**Regulation No. 16 (Safety-belts)**

## **Proposal for Supplement 2 to the 06 series of amendments**

### **Submitted by the experts from the GRSP Informal Group on CRS\***

*Key of Figure 1 to 7 of Annex 17- Appendix 2 amendment to read:*

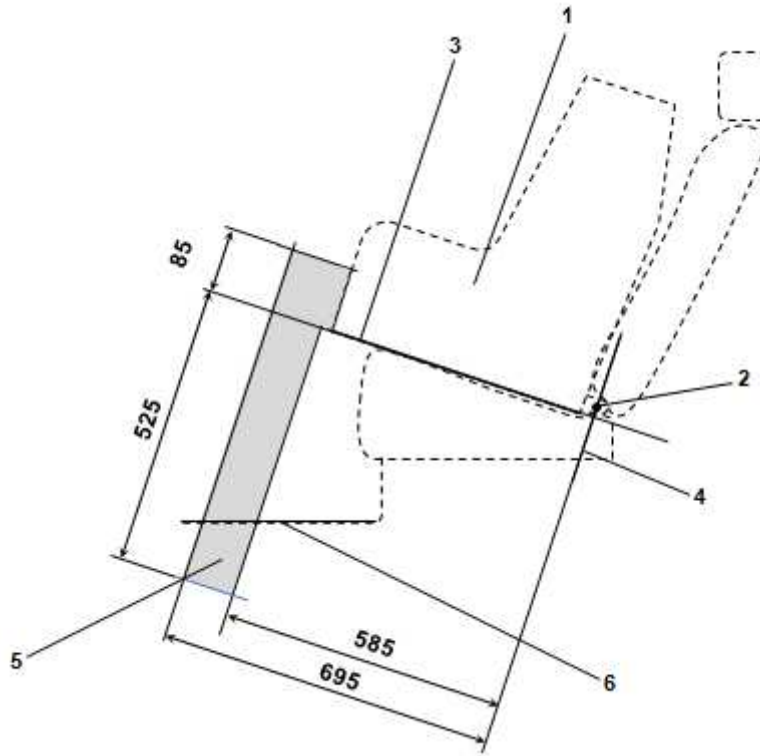
2 Dashed line marks area where a support leg, or similar, **of a specific vehicle CRS** is allowed to protrude

**Figure 8 -** Side view of the i-Size support leg installation assessment volume for compatibility assessment of i-Size seating positions with support legs of i-Size child restraint systems

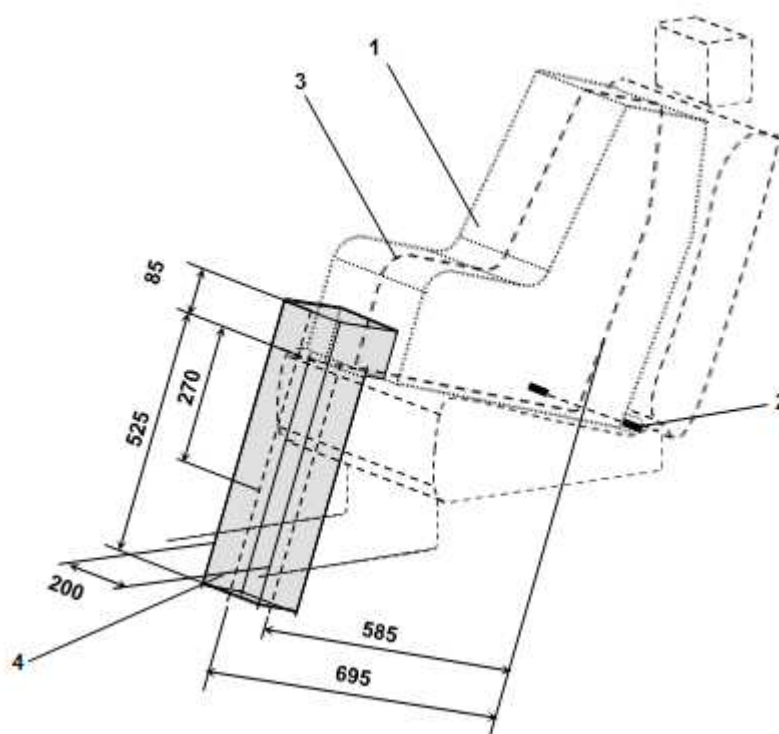
Add new Figures 8 and 9, incl. key to Annex 17- Appendix 2:

- 1 Child Restraint Fixture (CRF)
- 2 ISOFIX low anchorages bar
- 3 Plane formed by the bottom surface of the CRF when installed in the designated seating position
- 4 Plane passing through the lower anchorage bar and oriented perpendicular to the median longitudinal plane of the CRF and perpendicular to the plane formed by the bottom surface of the CRF when installed in the designated seating position
- 5 i-Size support leg installation assessment volume representing the geometrical boundaries for an i-Size ISOFIX child restraint system support leg.
- 6 Vehicle floor
